Meeting: 7/21/2021
Project: Pembroke Building Modifications
Applicant: Emmie Palmer

7-A-21-DT

APPLICATION FOR CERTIFICATE OF APPROPRIATENESS

510 Union Ave.
Level 1: Minor alteration of an existing
building/structure

2 NORTH ELEVATION DEMOLITION
B NOT TO SCALE

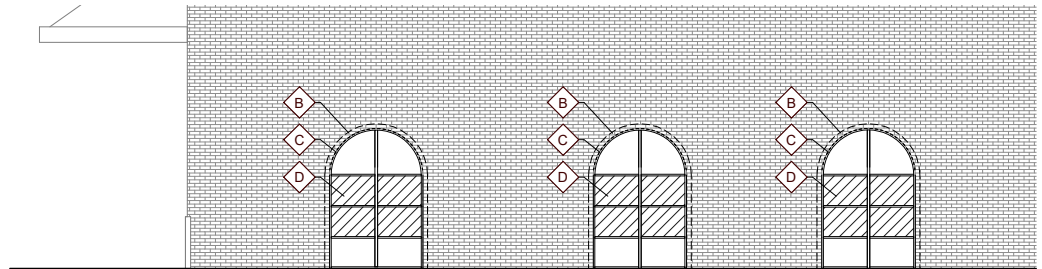
The proposed scope of work to the north elevation maintains the façade's rhythm of overall transparency. While guidelines recommend that ground floor window frames and doors be recessed from the exterior building face to provide depth to the façade, the removal of two recessed sections will not detract from the building's overall character. The façade already features an irregular pattern of doors, with the leftmost door (502 Union Ave) as slightly recessed double doors, a single recessed door on the following bay, followed by the primary entry and three angled single entries on the right side of the façade. The proposal does not include modifications to the round-arched primary entry. The project will retain the character-defining elements of the façade, including the marble-finished sill wall/low bulkhead, the beam between the transom and storefronts, and the transom window patterns. The proposed storefront systems will match the transom profile above, and are appropriate for the façade's height and width.

Staff recommends approval of Certificate 7-A-21-DT as submitted.
